Item Name: Crosstube Fwd

D407-667-145	Rev C (DEO)
--------------	-------------

DRAWING NO. D407-667-145	TITLE CROSSTUBE ASS'Y (407 HIGH FWD)	REV. C	DART AEROSPACE LTD ENGINEERING ORDER		D.E.O. NO. D407-667-145-C-1	SHEET NO. SHEET 1 OF 1	SCALE NTS
DRAWN <i>q</i>	CHECKED <i>ASS</i>	MFG. APPR. <i>IB</i>	APPROVED <i>WD</i>		DE APPR. <i>HH</i>		
DATE 11.07.15	DATE 11.07.22	DATE 11.07.22	DATE 11/07/22		DATE 11.07.21

DRAWING NO. D407-667-145	TITLE CROSSTUBE ASS'Y (407 HIGH FWD)	REV. C	DART AEROSPACE LTD ENGINEERING ORDER		D.E.O. NO. D407-667-145-C-2	SHEET NO. SHEET 1 OF 1	SCALE NTS
DRAWN AJ5	CHECKED	MFG. APPR. <i>E</i>	APPROVED <i>AD</i>	DE APPR. <i>AD</i>			
DATE 12.08.02	DATE 12.08.02	DATE 12.08.02	DATE 12.08.02	DATE 12.08.02

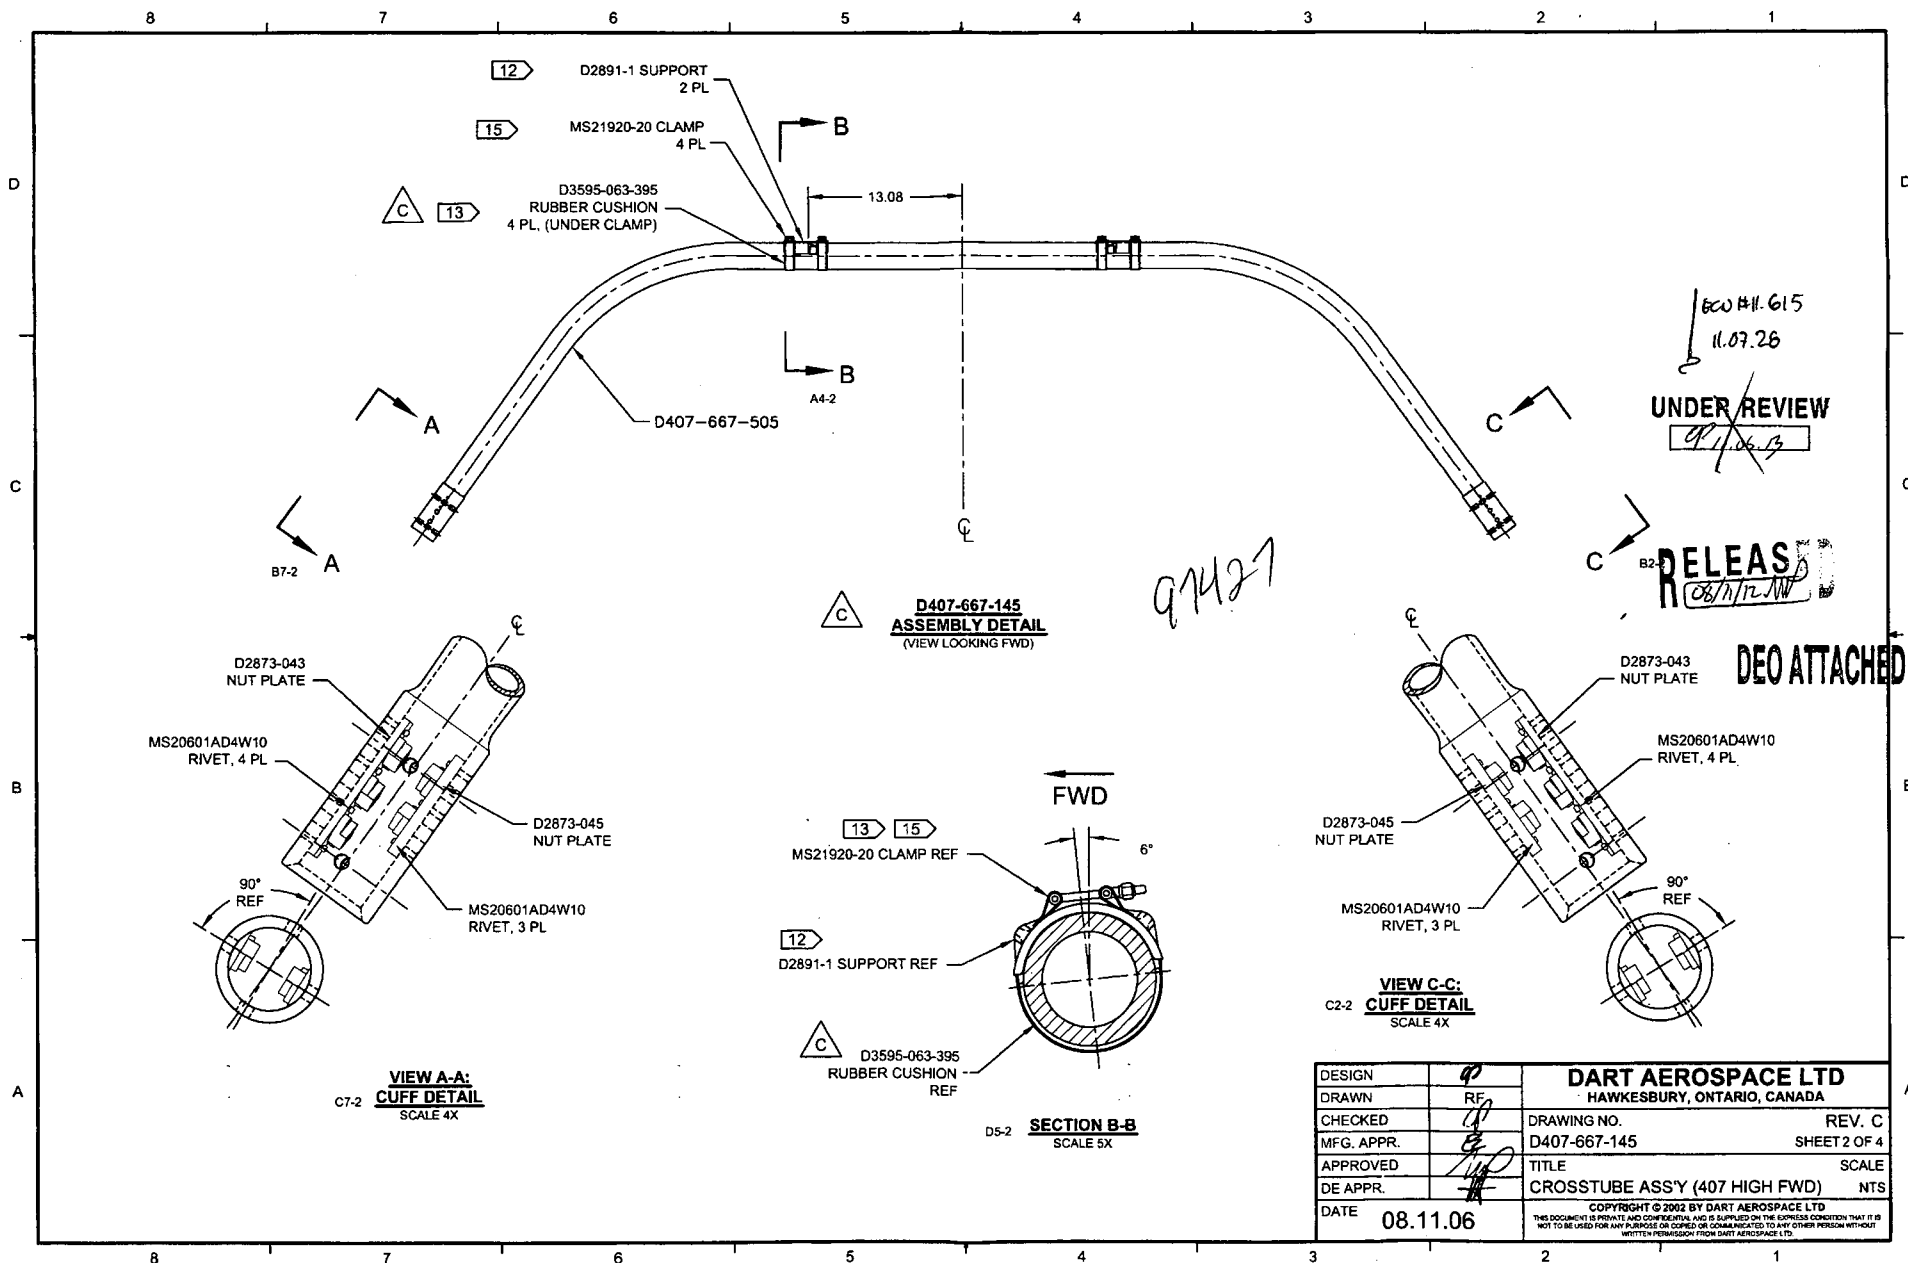
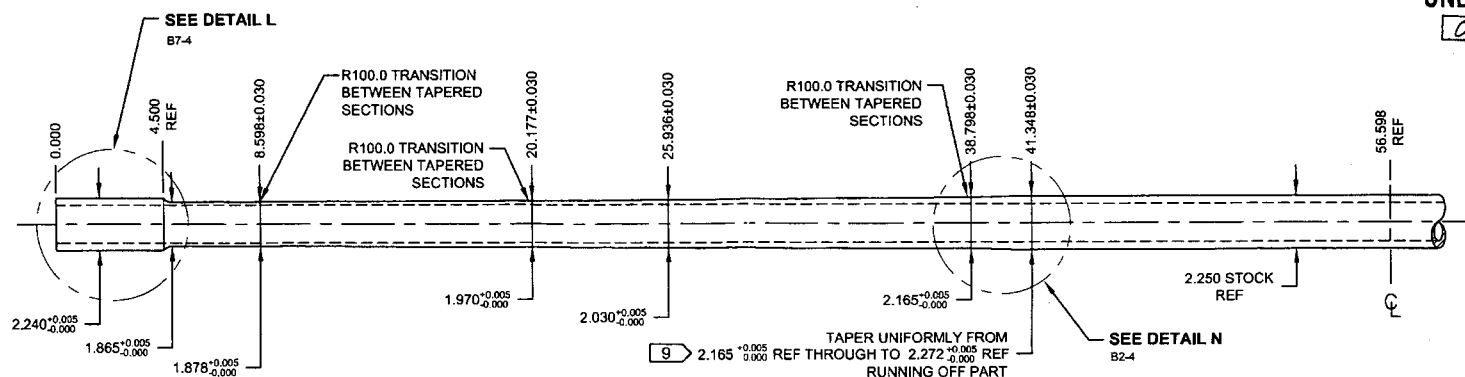
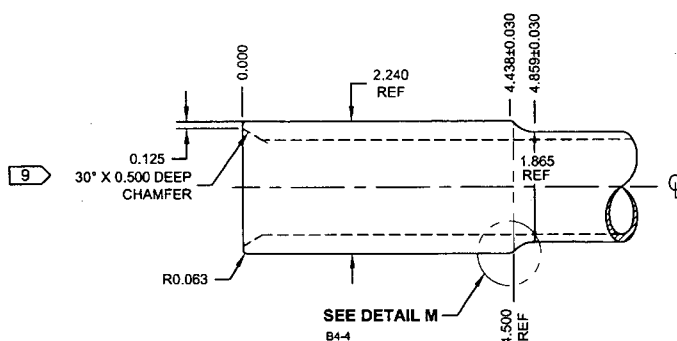
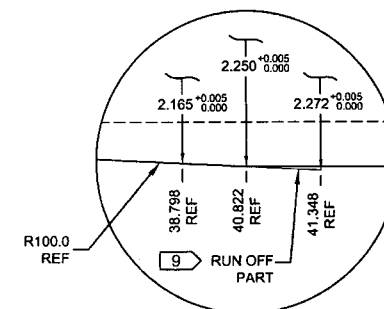
REPLACE MAGNOBOND WITH PROSEAL.

NOTE 12 & 15, SHEET 1 IS AMENDED AS FOLLOWS:

- 12) TO INSTALL D2891-1 SUPPORT: ABRASE MATING SURFACE OF SUPPORT AND CROSSTUBE WITH 180-GRIT SANDPAPER AND REMOVE RESIDUE WITH MEK (OR EQUIVALENT). APPLY A 0.04" TO 0.07" THICK LAYER OF PROSEAL 890 CLASS B-2 (OR AMS-S-8802 CLASS B-2) SEALANT TO MATING SURFACE OF SUPPORT.
- 15) TORQUE CLAMPS 80 TO 100 IN-LB. ENSURE AT LEAST 1.5 THREADS SHOWING IN SAFETY AND THAT NUT HAS NOT BOTTOMED-OUT AFTER TORQUING. **PRIOR TO PACKAGING, RE-CHECK TORQUE ON CLAMPS AFTER PROSEAL 890 SEALANT HAS CURED FOR 72 HOURS.**

DETAIL P
BONDING STRAP INSTALLATION 2 PL

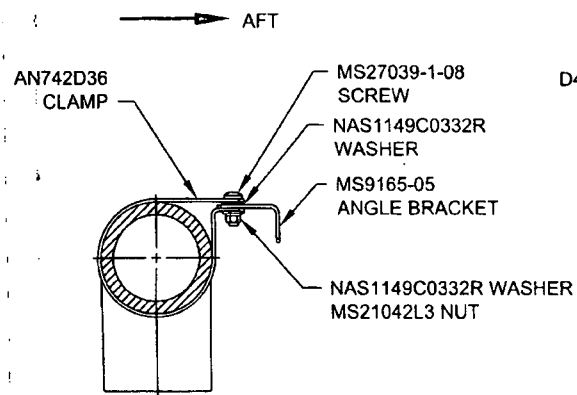
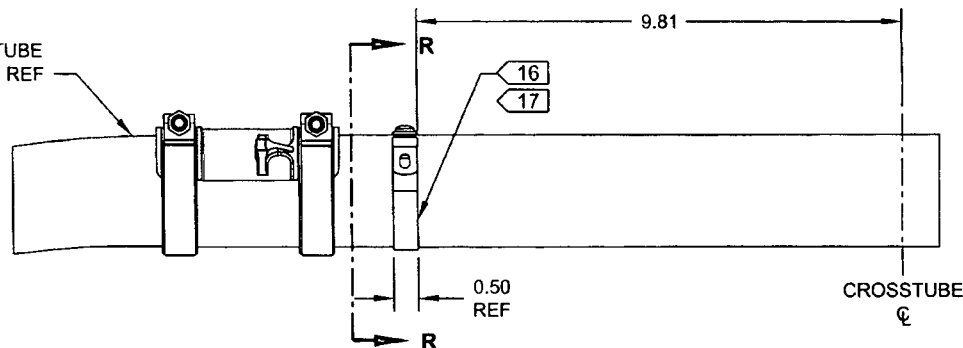
ADD ELECTRICAL GROUNDING STRAP

ITEM	QTY -145	PART NUMBER	DESCRIPTION
1	X	D407-667-145	CROSSTUBE ASSEMBLY (407 HIGH FWD)
10	2	AN742D36	CLAMP
11	2	MS9165-05	ANGLE BRACKET
12	2	MS21042L3	NUT (OR MS21042-3)
13	2	MS27039-1-08	SCREW
14	4	NAS1149C0332R	WASHER (OR AN960C10L)
